# Access Compliance Report

## Public Rights-of-Way

Intersection ID: 8650	Main Street: GARNETTE_PL	Cross Street: ST_MARK_ST	Location: SE
ADA ID: 77B508F71BFC	Ramp Type: Perp	Initial Pass/Fail: Fail	Overall Compliance: No Severity Score: 21.25

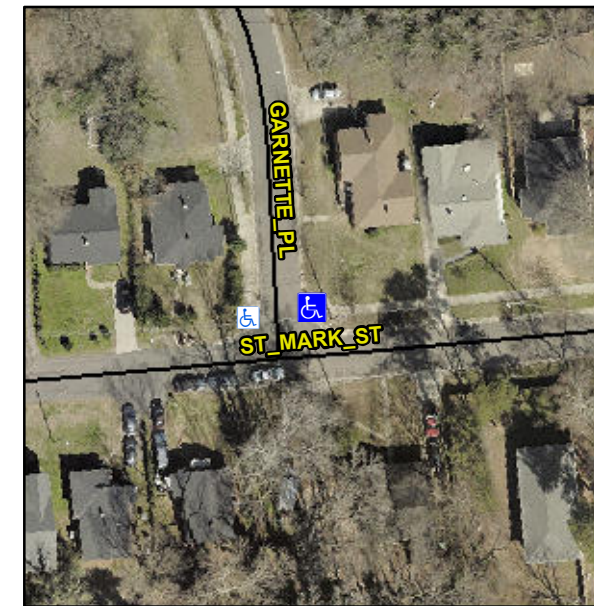
**Not Found, R304.5.1, R304.2.2**

Compliance	Description	Data	Compliance	Description	Data
N/A	Ramp Length (in)	73.0	No	Ramp Slope (%)	8.7
No	Ramp Width (in)	47.5	Yes	Ramp XSlope (%)	1.4
N/A	Flare Type LT	N/A	N/A	Flare Type RT	N/A
N/A	Flare Slope LT (%)	N/A	N/A	Flare Slope RT (%)	N/A
N/A	Flare Traversable LT?	N/A	N/A	Flare Traversable RT?	N/A
N/A	Landing Length (in)	N/A	N/A	DWS Provided?	N/A
N/A	Landing Width (in)	N/A	N/A	DWS Contrast?	N/A
N/A	Landing Slope (%)	N/A	N/A	DWS Length (in)	N/A
N/A	Landing X Slope (%)	N/A	N/A	DWS Full Width?	N/A
N/A	Landing Curb? (Y/N)	N/A	N/A	DWS Offset (in)	N/A
N/A	Shared Landing?	N/A			
N/A	Gutter Ponding?	N/A	N/A	Gutter Slope (%)	N/A
N/A	Gutter Lip Ht (in)	N/A	N/A	Gutter X Slope (%)	N/A
N/A	Painted X Walk1?	No	N/A	Painted X Walk2?	N/A
	X Walk 1 Direction	To W		X Walk 2 Direction	N/A
N/A	X Walk 1 Width (in)	N/A	N/A	X Walk 2 Width (in)	N/A
	X Walk 1 Slope (%)	4.3		X Walk 2 Slope (%)	N/A
	X Walk 1 X Slope (%)	1.6		X Walk 2 X Slope (%)	N/A

**Remove & Replace Entire Ramp.**
